REV.
A

AS9527

SCREW, MACHINE STEEL UNS G87400,
CADMIUM PLATE, DRILLED, 1 HOLE,
HEXAGON HEAD, .1380-40 UNJF-3A

ISSUED 2000-08 REAFFIRMED 2004-07 REVISED 2007-09

FIGURE 1 - SCREW

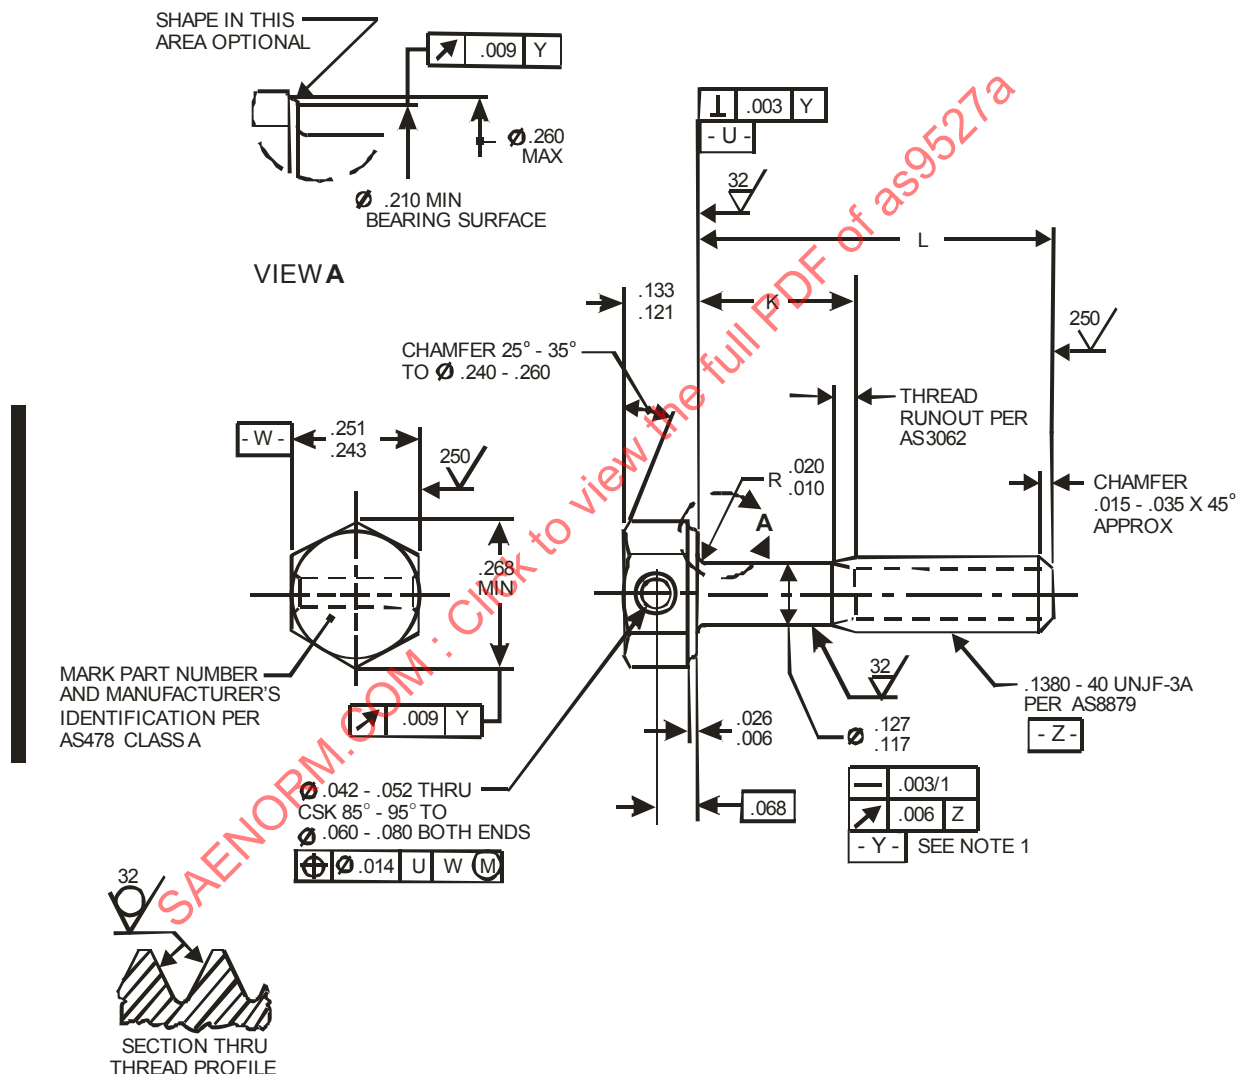
STANDARD UPDATED, CADMIUM WARNING NOTE ADDED, THREAD SPECIFICATION REVISED TO AS8879, AND GEOMETRIC CONTROLS FOR SHORT LENGTH SCREWS CLARIFIED TO AGREE WITH AS1132.
